Examiner’s questions	Colwall Parish Council Response
<p>1. Would you provide me with an update of Table 2 on completed developments and commitments.</p> <p>Is the assumption that 24 dwellings will be deliverable through windfall plots in the remaining plan period reasonable?</p>	<p>Refer to HC response.</p>
<p>2. Would the QB and HC advise me on the delivery of housing in the parish over the last 3 years in view of the comment in the representation by Collins that is promoting a buffer of 20%. NPPF para 73 calls for a buffer of 20% where there has been significant under delivery of housing over the previous 3 years.</p>	<p>Herefordshire Council has advised that the proportional growth target for Colwall Parish is 160. To date built development and commitments comprise 130 dwellings with 11 years of the plan period remaining.</p> <p>In Herefordshire housing delivery is calculated on a countywide basis and not on a parish level. The Housing Delivery Test shows that from 2016-2019 Herefordshire had provided 80% of the housing required. This is an increase of 6% from last year.</p> <p>Herefordshire Council's report on the Five Year Housing Land Supply (2020 - 2025) Annual Position Stat

Map 2 Grovesend Farm Site Allocation

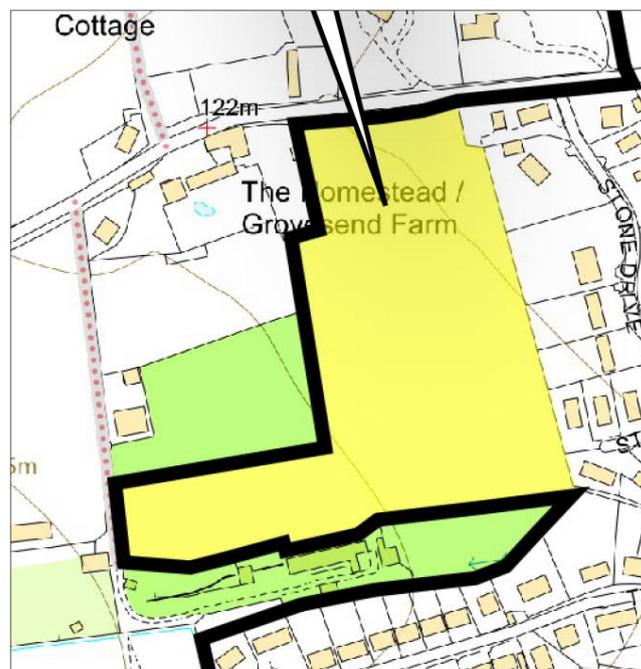
9. What is the status of the Malvern Hills AONB Highways Design Guide? Should it be cross referenced from the justification in the policies in the plan itself rather than in in Appendix I?	Refer to HC response.
<p>10. Policy CD4 Grovesend Road - Would the QB explain why the land to the west and south of the housing allocation has been included in the Plan as public open space. It is noted that part of it is shown on the indicative layout plan as subject to landowner agreement.</p> <p>Also it is shown incorrectly on the Policies Map as a Local Green Space instead of a proposed green space.</p> <p>Would the QB comment on the suggestion by the landowner that these areas of open space should be omitted and open space should be included in the site allocation itself.</p>	<p>Please refer to the previously submitted document, Parish Council Response to Regulation 16 Comments Objecting to Site Allocation Policy CD4 Site 2 Grovesend Farm (Approximately 32 houses) 28 July 2020.</p> <p>The area identified as open space has been protected as open space in the NDP in response to recommendations in the LSCA:</p> <p>'Area 12B (Parts 1 and 2) are assessed as having an overall capacity for development of Low to Medium / Low and the report sets out 'Development would have adverse effects on landscape character / visual amenity / GI - area not recommended for consideration. Levels of quality / value / GI function could be increased by creating new community green space in field with access from E and W and restoring / protecting heritage assets.'</p> <p>The approach in the NDP is to identify the area most suitable for new housing development as the housing site allocation (shown in yellow), and to exclude the area identified as Area 12B in the LSCA. This area should be protected as green / open space.</p> <p>The error is on the Herefordshire Council Policies Map. The area is shown on the Policies Map in the NDP (p32) as "Allocated development sites - Green Space".</p> <p>The Parish Council would prefer to retain these two areas as open space as shown on the NDP Policies Map. If the green areas were to be included within the site allocation boundary then there would be a greater risk of built development in areas that should be protected.</p>

Examiner’s questions	Colwall Parish Council Response
	However, if the Examiner recommends the site allocation boundary is extended to include the green / open space, then the Parish Council requests that the colouring to indicate green space should be retained.
